## ADDENDUM #2

### RSU #57 – DESIGN-BUILD MODULAR CLASSROOM BUILDING PROJECT

86 West Road, Waterboro, Maine

23 February 2024

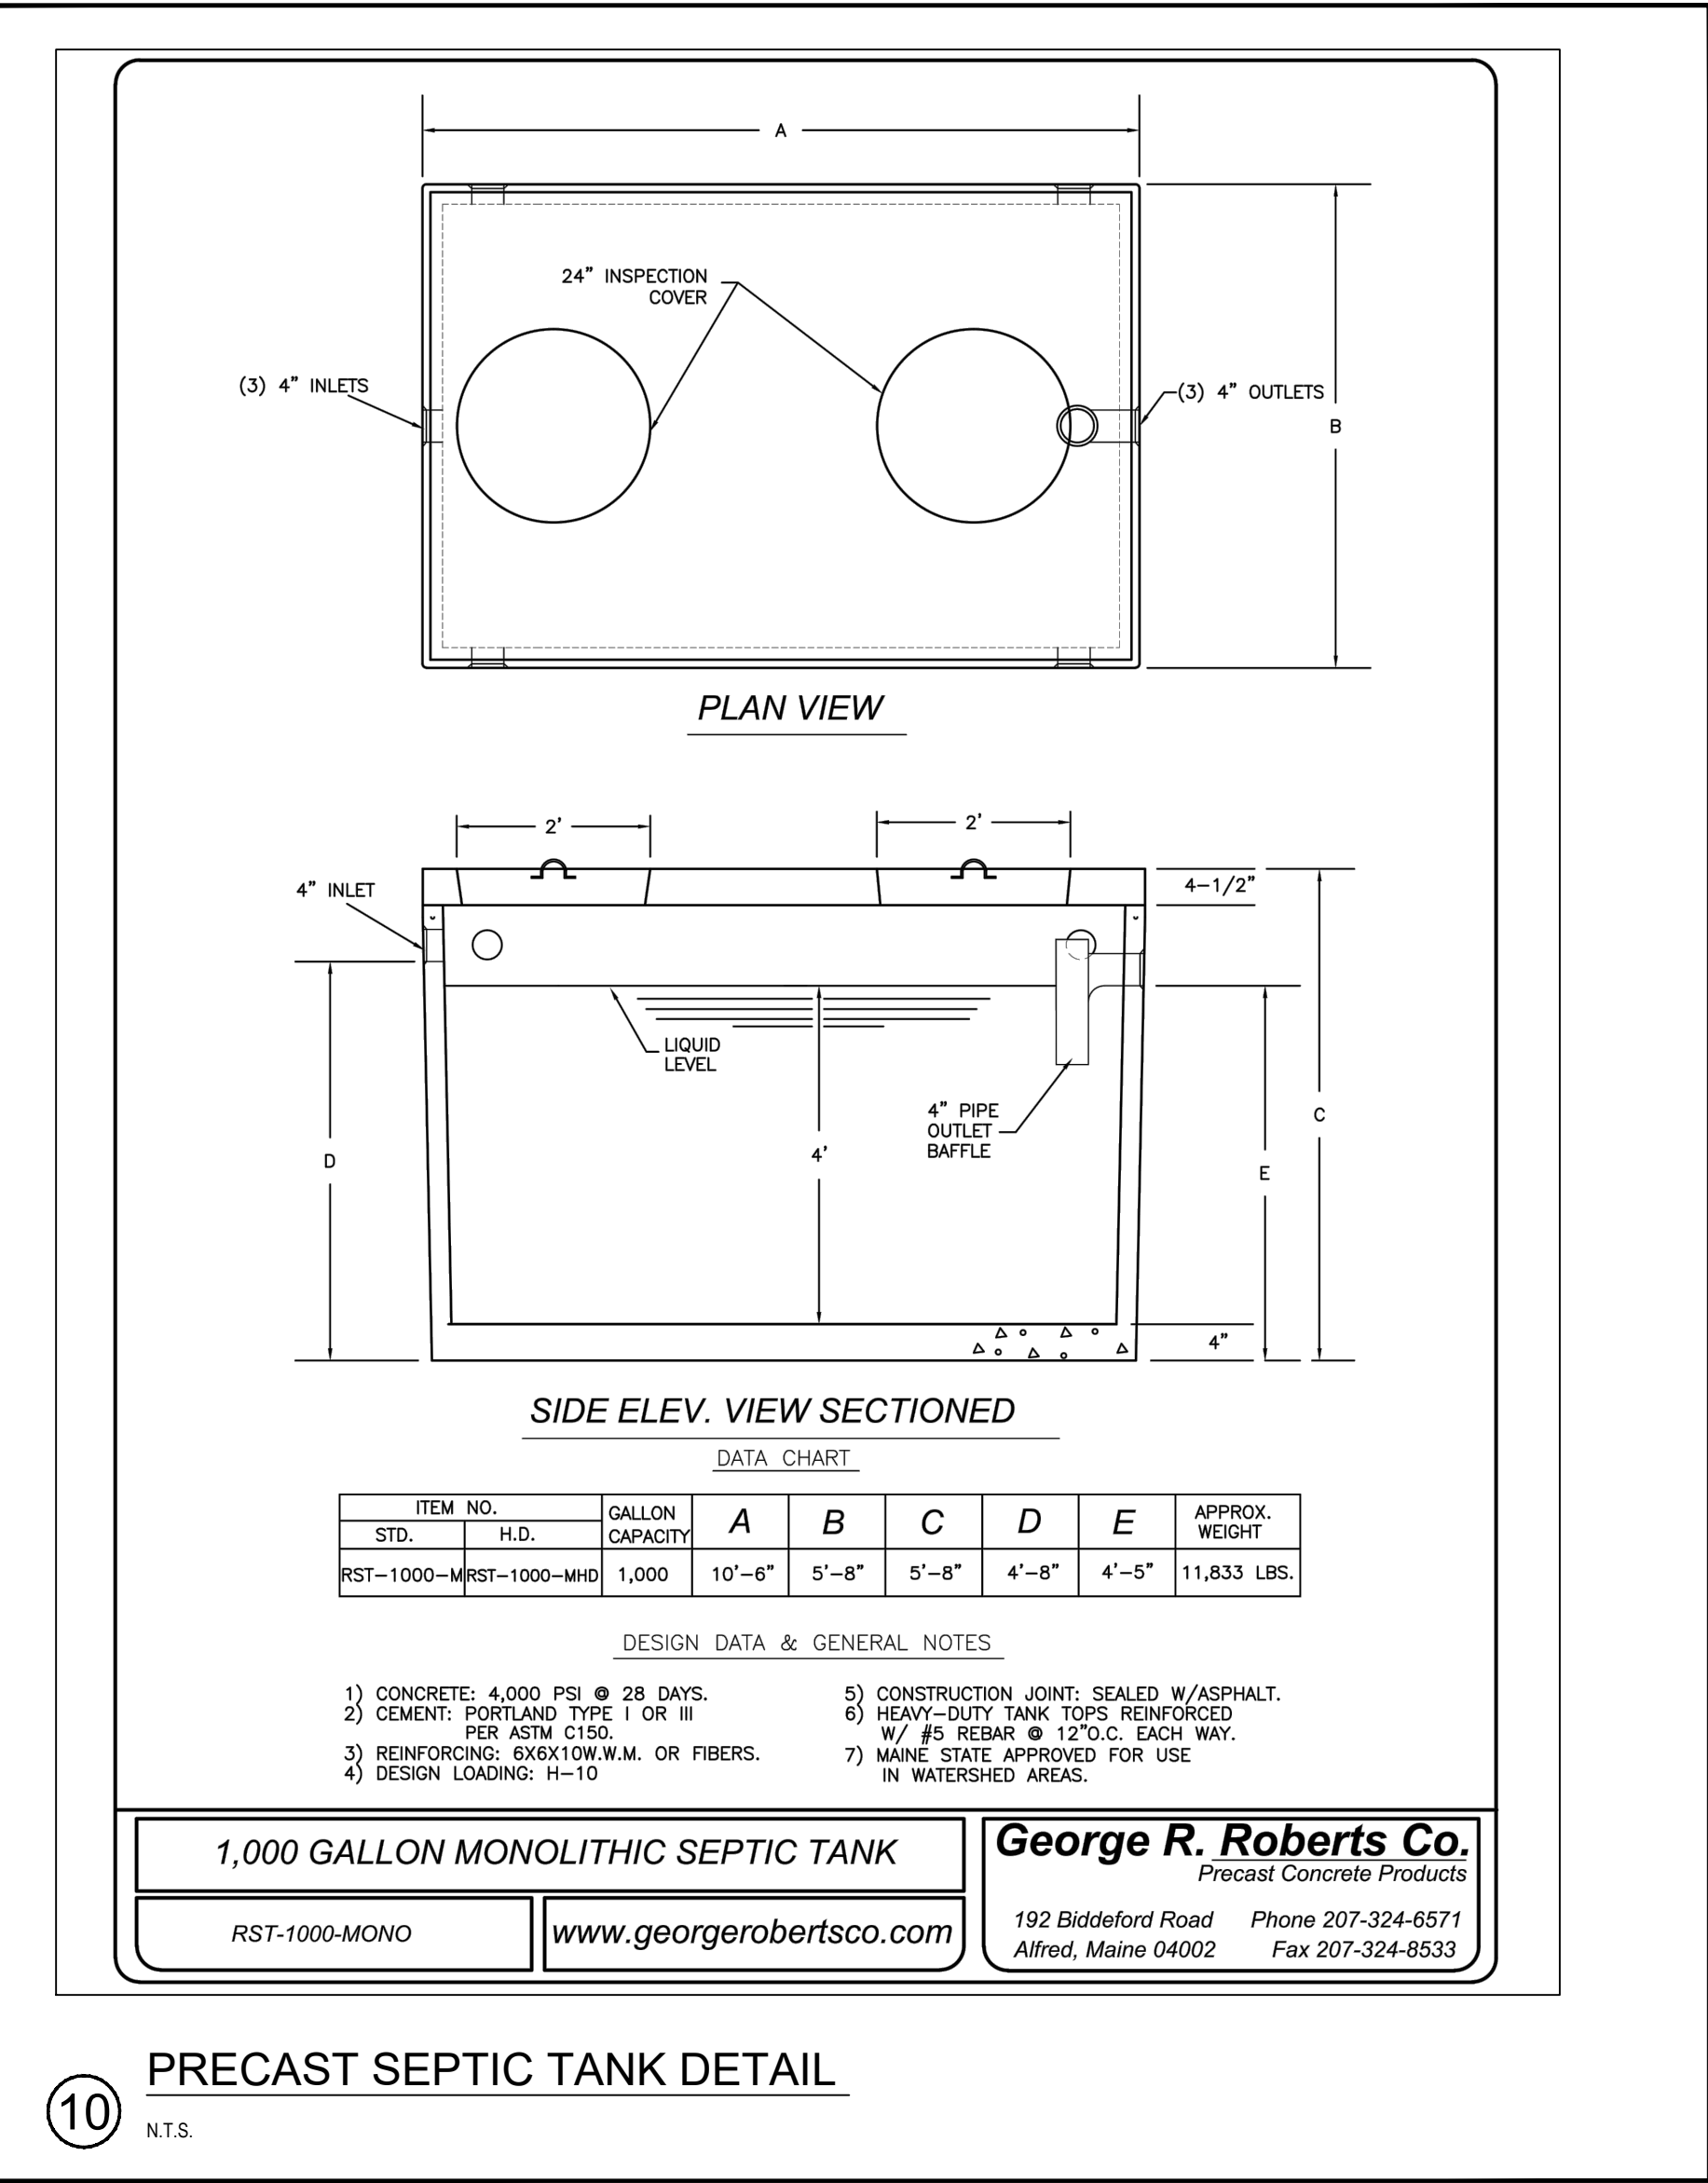
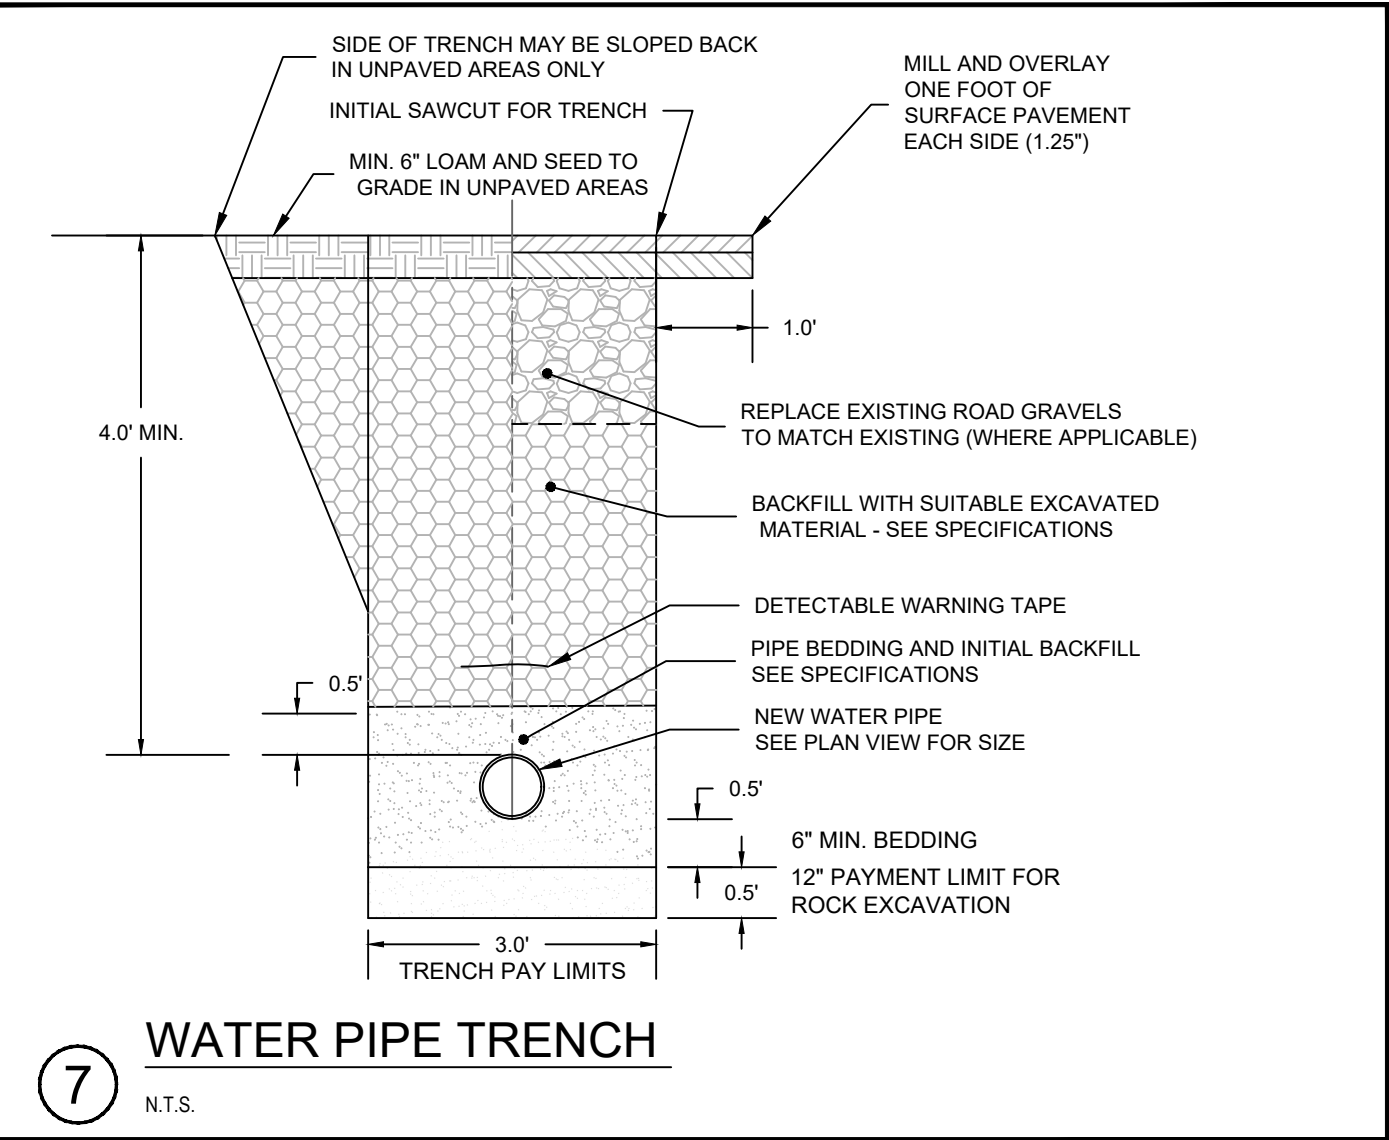
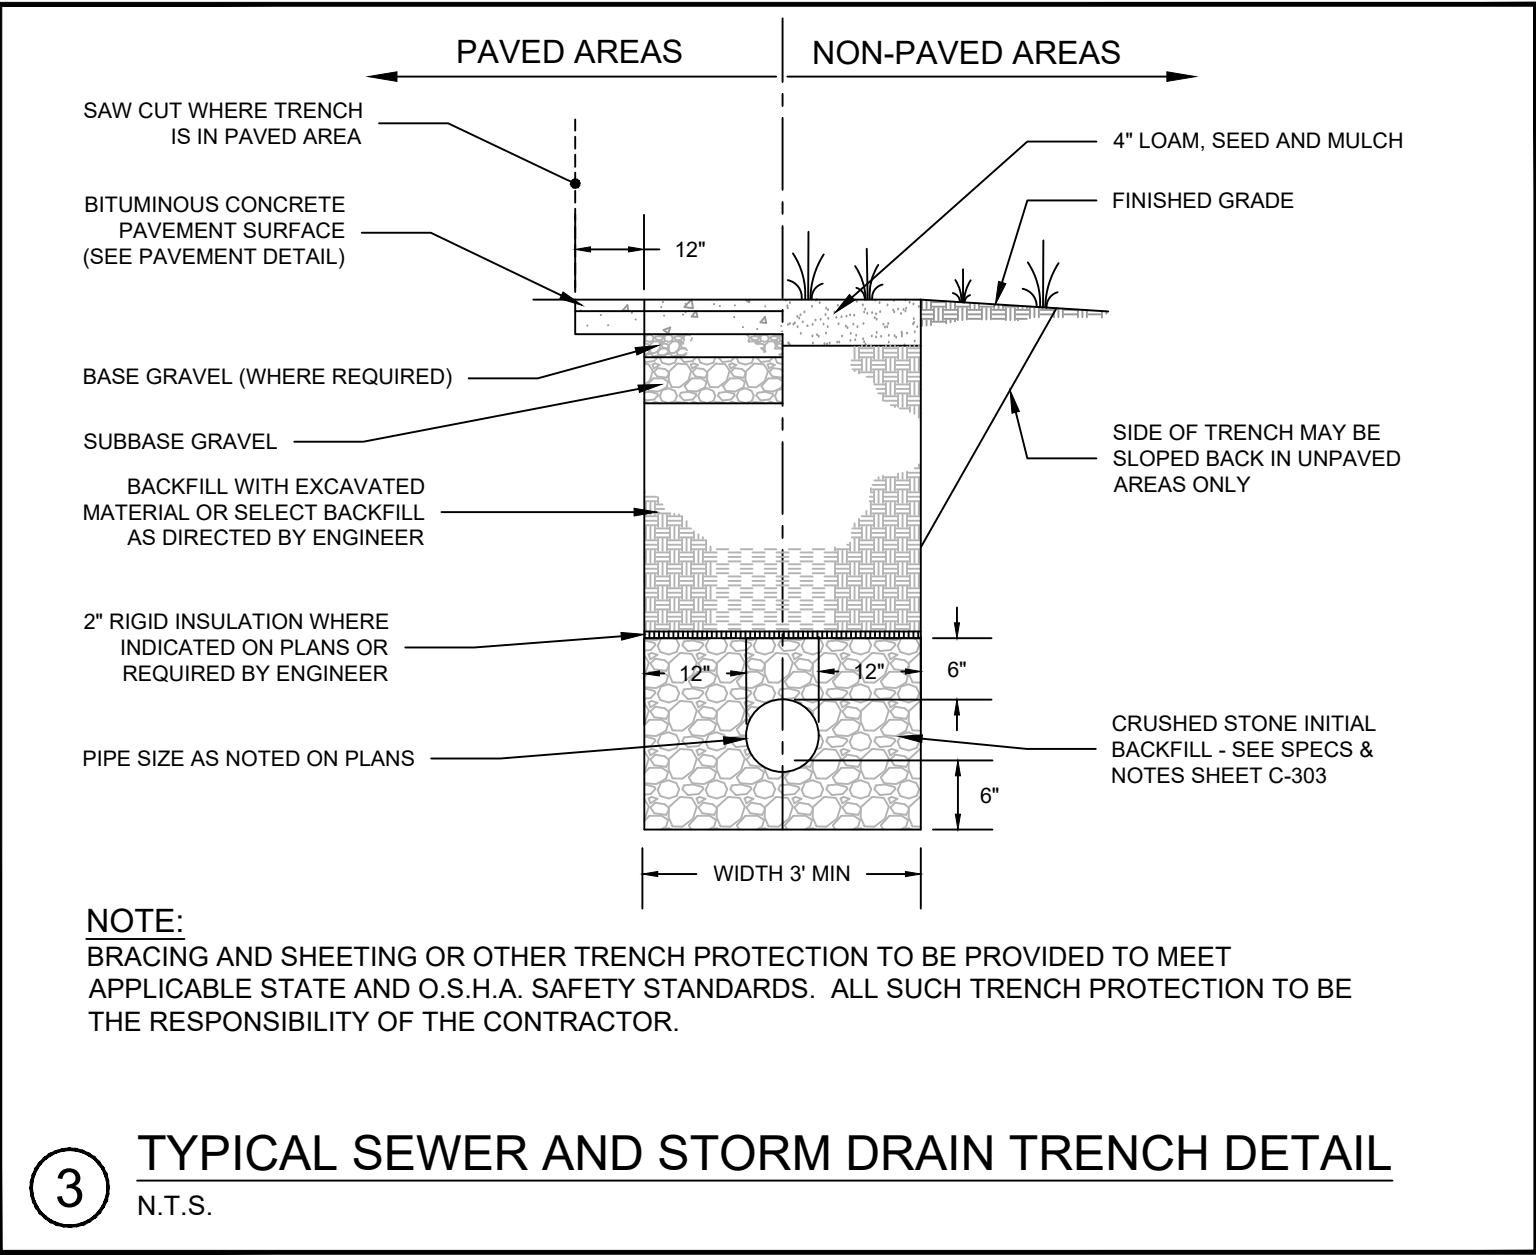
1. Delete drawing C-101A, Portable Classroom Context Plan; and insert the attached revised drawing C-101A, Portable Classroom Context Plan; changes include a revision to the Project Area limit of work.
2. Delete drawing C-101B, Portable Classroom Site Plan; and insert the attached revised drawing C-101B, Portable Classroom Site Plan; changes include revisions to show an underground communications pathway and the new sewer manhole is changed to a septic tank.
3. Delete drawing C-301, Portable Classroom Site Civil Details; and insert the attached revised drawing C-301, Portable Classroom Site Civil Details; changes include the addition of a precast septic tank detail.
